24th August 2005

Reg. No.: 131-1

**Re: Clarification of Response to the Article 14(2)(b)(ii) of the Waste
Management (Licensing) Regulations**

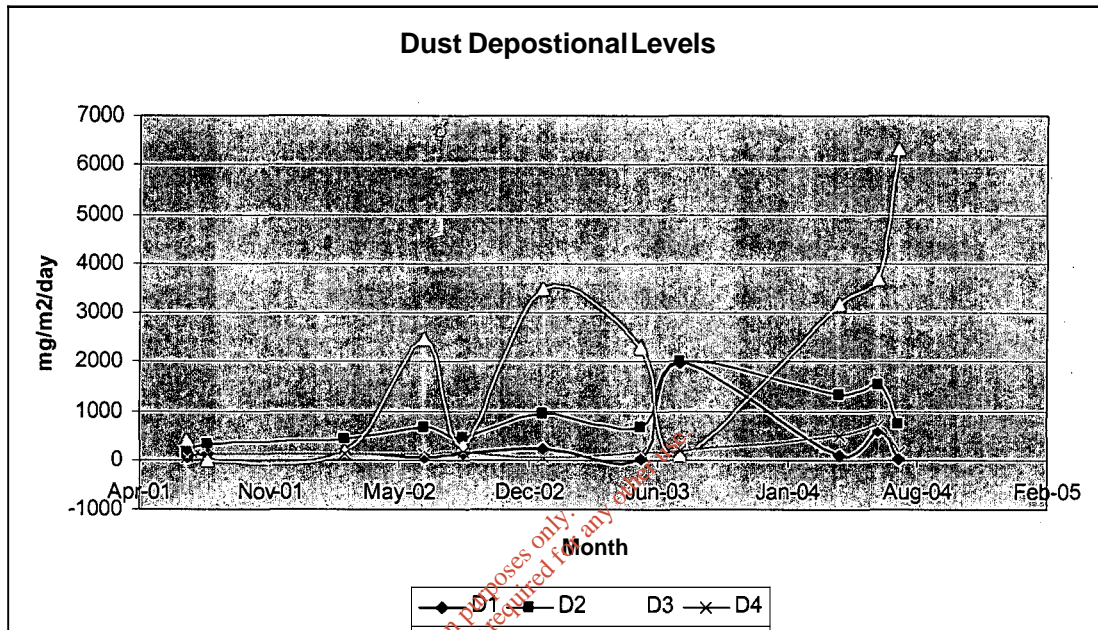
1. Please find attached correspondence from Meath County Council confirming the use of the treatment plant.
8. ***Provide a summary and interpretation of the results for dust, noise, surface water discharge, groundwater and gas monitoring results.***

In general, the results of the dust monitoring have shown higher levels of dust along the northern boundary of the facility (D2 & D3) in comparison to the southern (D1) and eastern (D4) sections, as illustrated below. D2 & D3 are located along the roadway, and close to an adjacent industrial site. The movement of traffic along the roadway is considered to be the predominant source of the dust detected along this boundary. Dust directional gauges at these monitoring stations predominantly indicate that dust is being generated from the east and west (traffic movement) and from the north (off-site activities), rather than from the working areas of Midland Waste Disposal Company Ltd.
